SAFETY EVALUATION BY THE OFFICE OF NUCLEAR
REACTOR REGULATION REGARDING
LICENSING TOPICAL REPORT NEDE-33766P FOR
GEH SIMPLIFIED STABILITY SOLUTION
GE-HITACHI NUCLEAR ENERGY AMERICAS LLC

Attachment: Resolution of Comments (Non-Proprietary)

Figure 1 - Typical stability exclusion region in the power-flow map

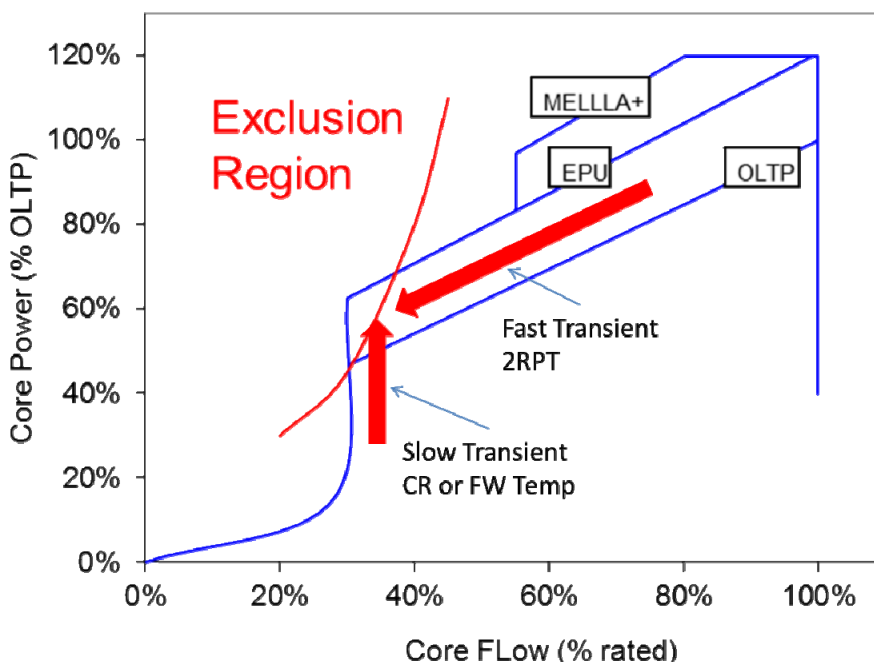
Long term stability (LTS) solutions are designed to protect the reactor for two different types of transients (See **Figure 1** for reference):

manually by the operator, but the LTS are designed to provide protection. Using **Figure 1** as a reference, this type of event would start at low flow-low power, and slowly increase power by either withdrawing control rods or from an unexpected FW heater transient.

2. Fast transients associated with loss of recirculation flow. These transients occur when one or two recirculation pumps are tripped. The instability region may be entered fully and rapidly, resulting in large amplitude oscillations that would be hard to manage manually by the operator. For this event, the initial operating conditions would be a full power and the flow reduction (e.g., a recirculation pump trip) would force a trajectory parallel to the blue lines in **Figure 1**, which would enter the exclusion region.

Fast RPT as described in the second transient above are, thus the most challenging transients from the point of view of instability and are used to verify the adequacy of the LTS scram setpoints. Experience has shown that the [
